# PERMIT

## SEWAGE DISPOSAL SYSTEM

ADDRESS 10439 Frederick Road, Ellicott City, MD 21043 PHONE 461-3255

# GRADING STUDY PLAT

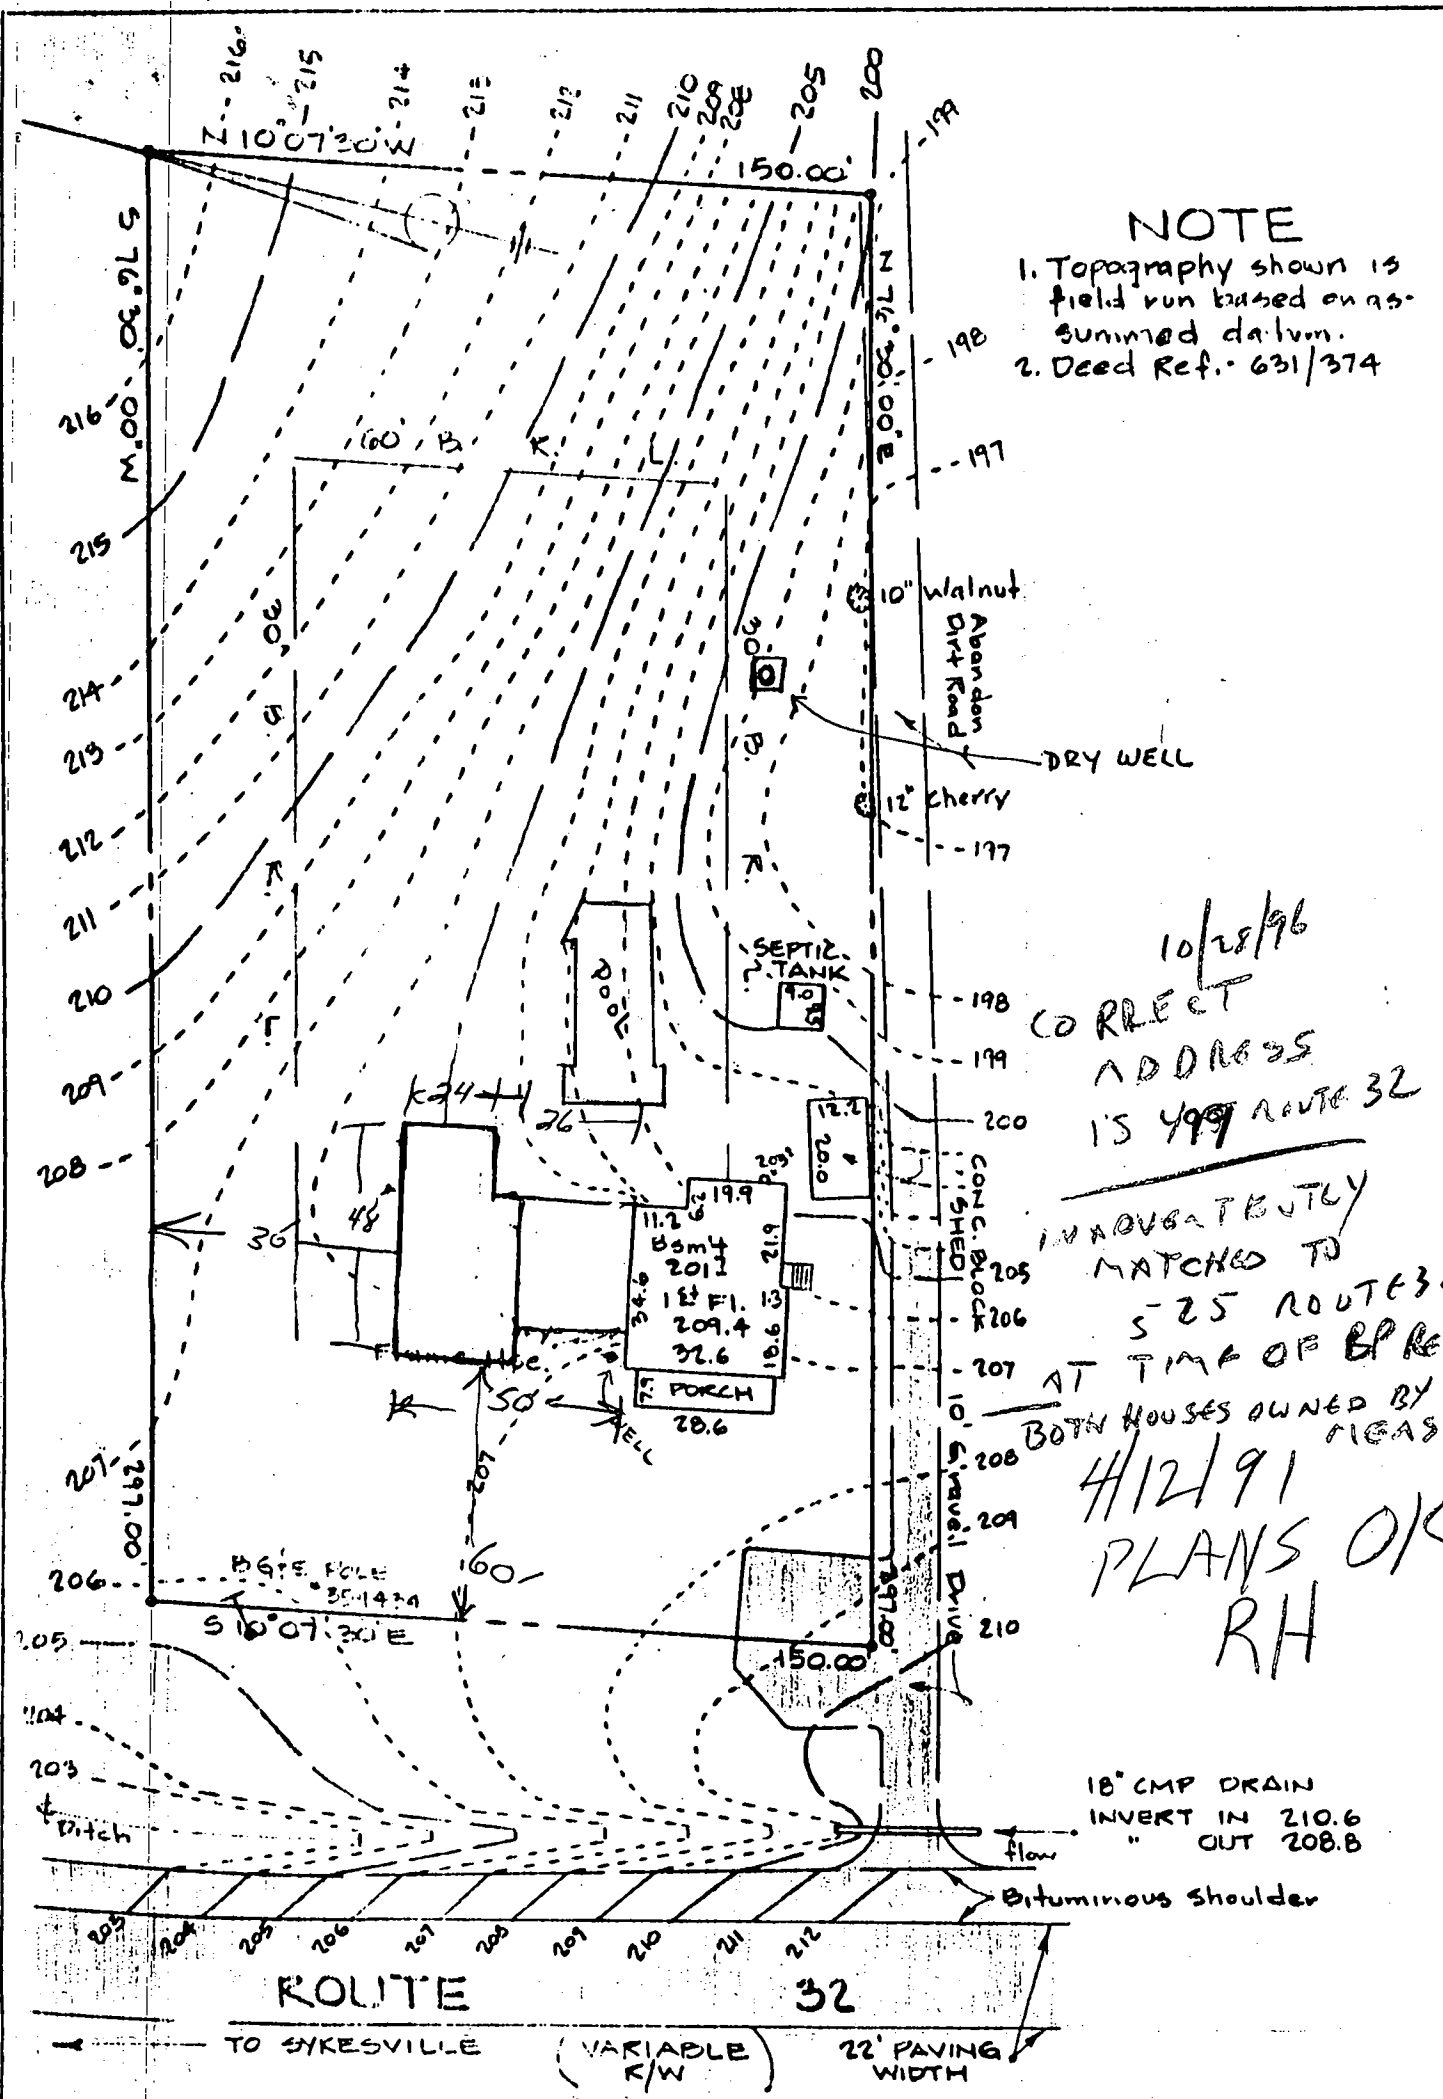
REMARKS: COLLAPSED TANK REPLACED - POINT OF DISCHARGE NOT KNOWN,  
TOPOGRAPHY IS SUSPECT (ROCK TO LEFT SIDE, SWALE TO RIGHT)  
CONTRACTOR REPORTS NO EVIDENCE OF CLOGGING IN DISCHARGE LINE (ORANGEBURG)  
10/25/96 CW

GRADING STUDY - GARAGE ADDITION - MCGINN PROPERTY

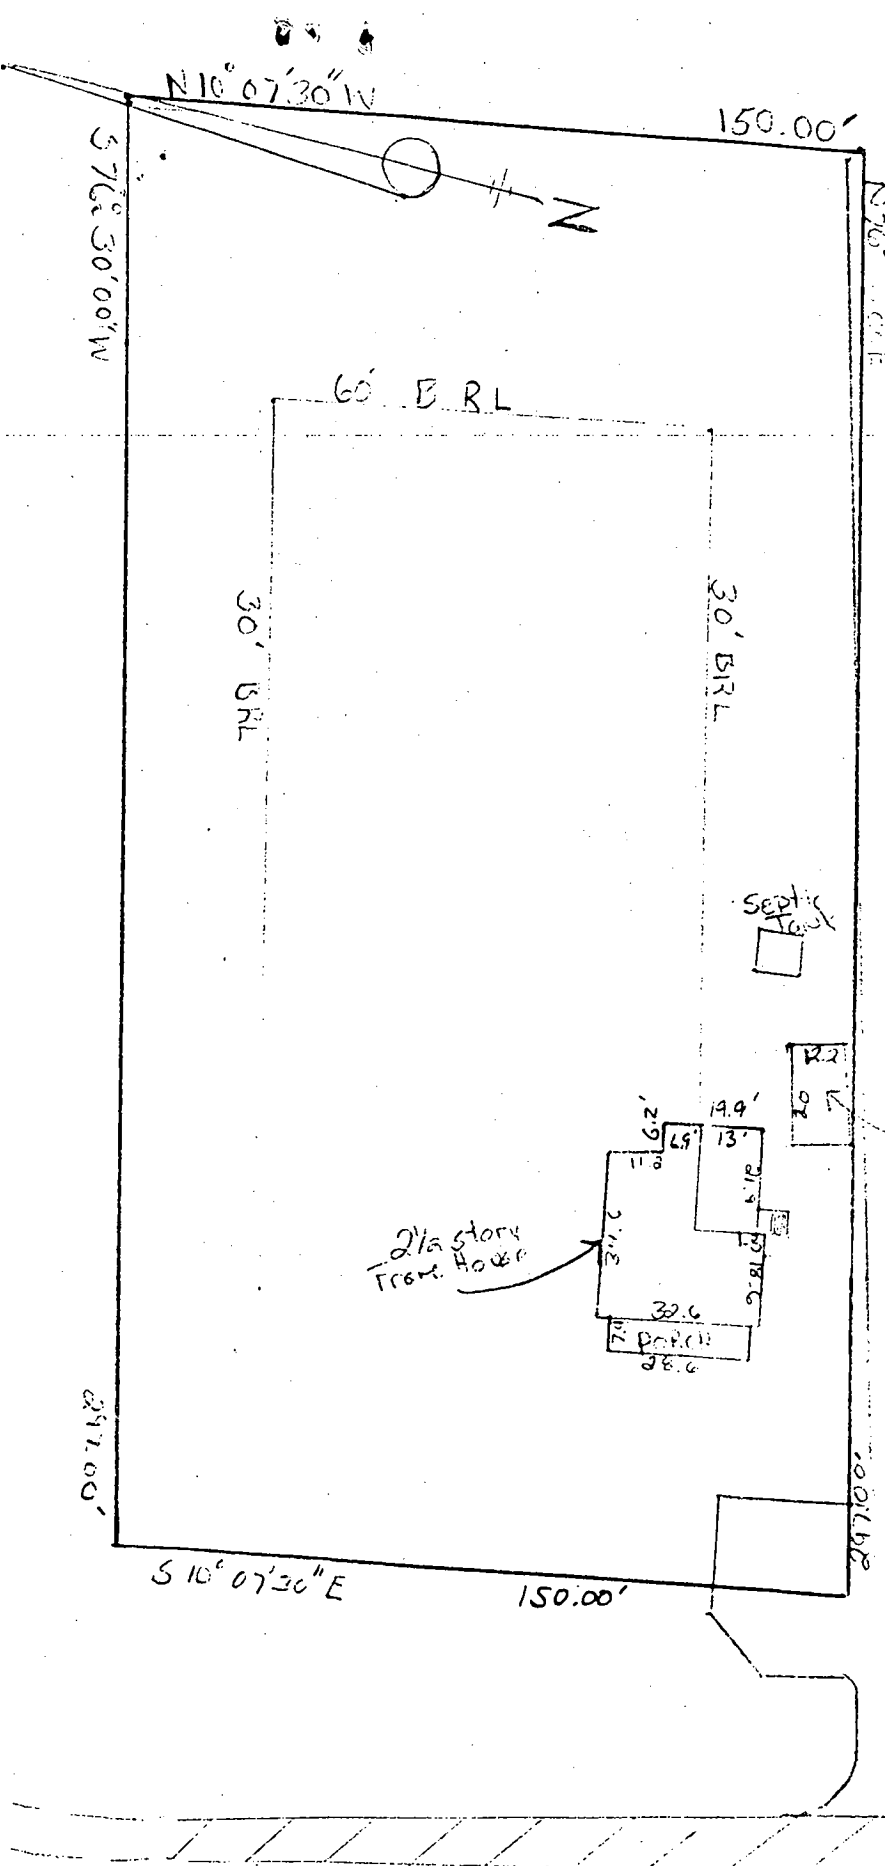
EXISTING SEPTIC  
APPEARS OK.  
IS LOCATED IN  
AREA SHOWN AS  
"NEW PAVING"

SYMBOLS DESIGNATED  
"EXISTING SEPTIC"  
"EXISTING DRYWELL"  
INDICATE PROPOSED  
RELOCATION OF  
SYSTEM.

EXISTING SYSTEM  
INSTALLED BY  
JOHN SCHNEIDER -  
ADDRESS ON PERMIT  
WE SHOULD  
NOTIFY HIM OF NEED  
FOR SEPTIC REPAIR  
PERMIT FOR THIS

INFO FROM MCGINN'S  
MOTHER WHO LIVES  
NEXT DOOR

4/13/84 T.C. & Mr. Measmer, existing drywell with cleanout is ~100' from house. He wants to install new tank only. I suggested new tank be located ~25' from edge of new paving to allow for future repairs between new tank & existing drywell. Mr. Measmer will secure septic repair permit & we will then release his Building Permit. F.A.
